MISSISSIPPI POWER & LIGHT COMPANY

June 22, 1984

SUBJECT: Grand Gulf Nuclear Station
Unit 1
Docket No. 50-416
License No. NPF-13
File 0260/0840/L-860.0
Proposed Amendment to the
Operating License
(PCOL's-84/11B, 13D, 14C,
and 16)
AECM-84/0319

FIGURE 4.7.4-1
SAMPLE PLAN 2) FOR SNUBBER FUNCTIONAL TEST

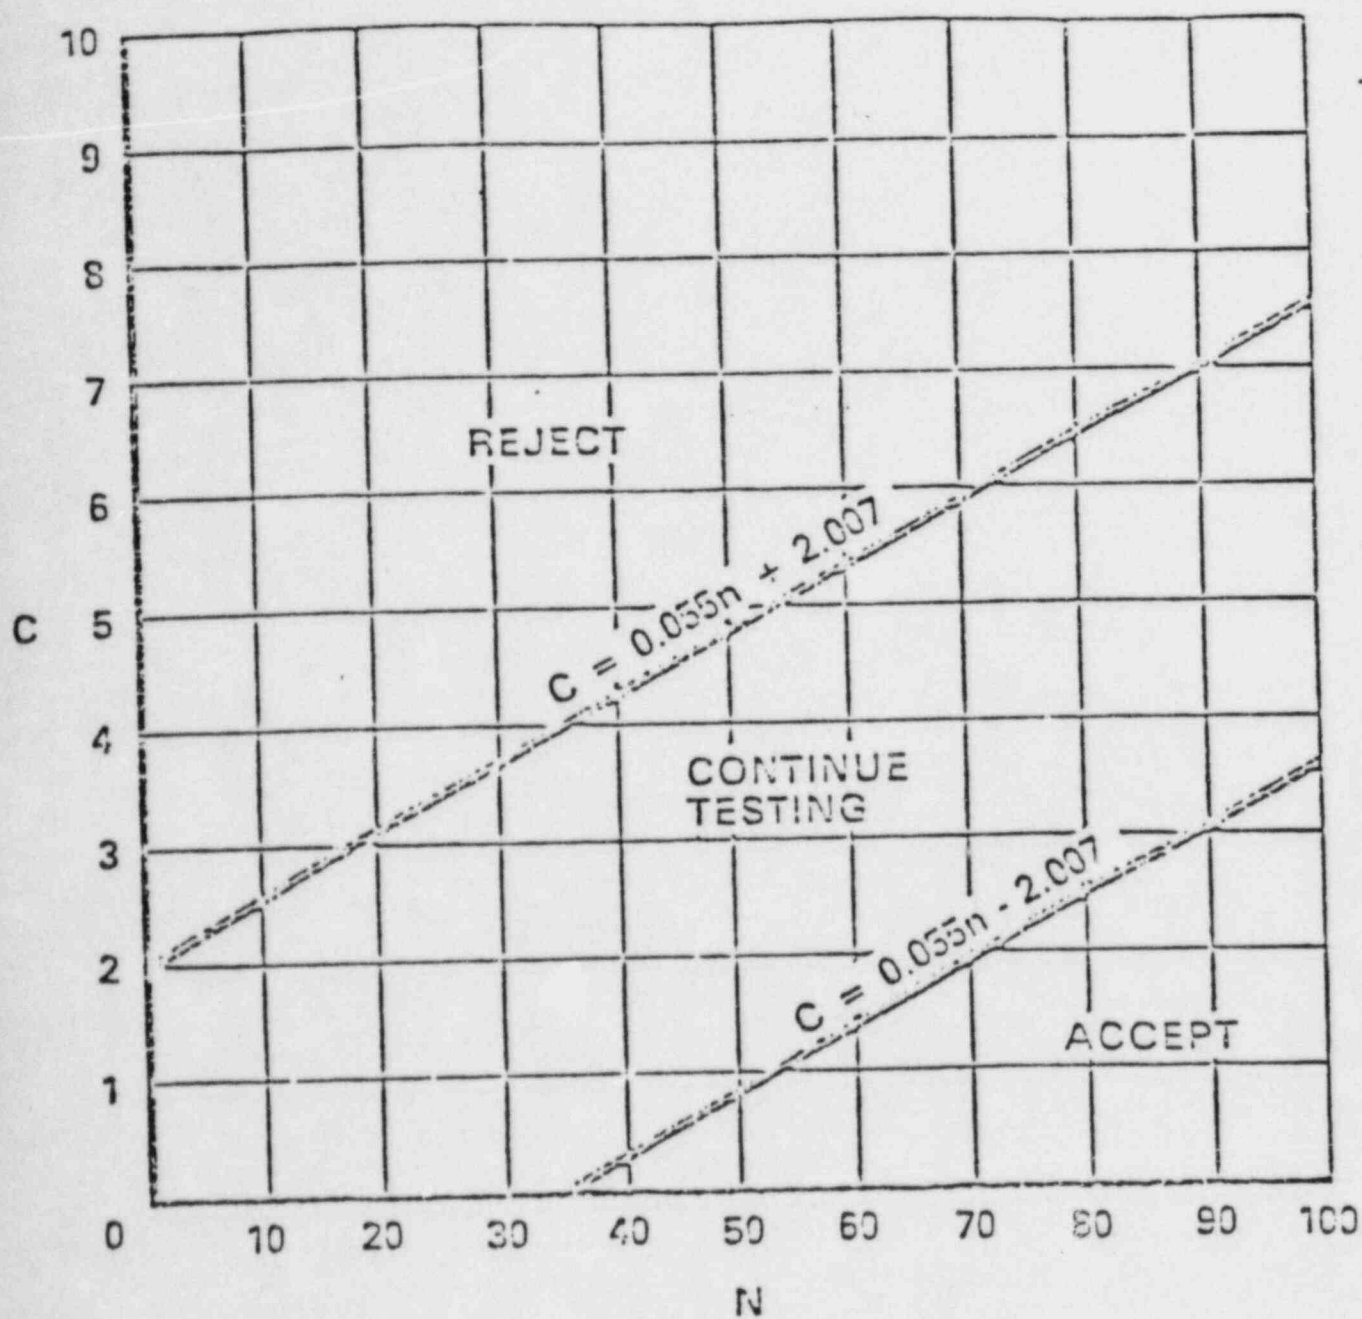
- k. Figure 4.7.4-1 is added to the surveillance requirement to be used when Surveillance Requirement 4.7.4.e.2 is chosen as the option for functional testing of the snubbers. This figure was developed using "Wald's Sequential Probability Ratio Plan" as described in "Quality Control and Industrial Statistics" by Acheson J. Duncan. This reference is included in the bases.

- 2) A representative sample of each type of snubber shall be functionally tested in accordance with Figure 4.7.4-1. "C" is the total number of snubbers of a type found not meeting the acceptance requirements of Specification 4.7.4f. The cumulative number of snubbers of a type tested is denoted by "N". At the end of each day's testing, the new values of "N" and "C" (previous day's total plus current day's increments) shall be plotted on Figure 4.7.4-1. If at any time the point plotted falls in the "Reject" region all snubbers of that type shall be functionally tested. If at any time the point plotted falls in the "Accept" region, testing of snubbers of that type may be terminated. When the point plotted lies in the "Continue Testing" region, additional snubbers of that type shall be tested until the point falls in the "Accept" region or the "Reject" region, or all the snubbers of that type have been tested. Testing equipment failure during functional testing may invalidate that day's testing and allow that day's testing to resume anew at a later time, providing all snubbers tested with the failed equipment during the day of equipment failure are retested; or
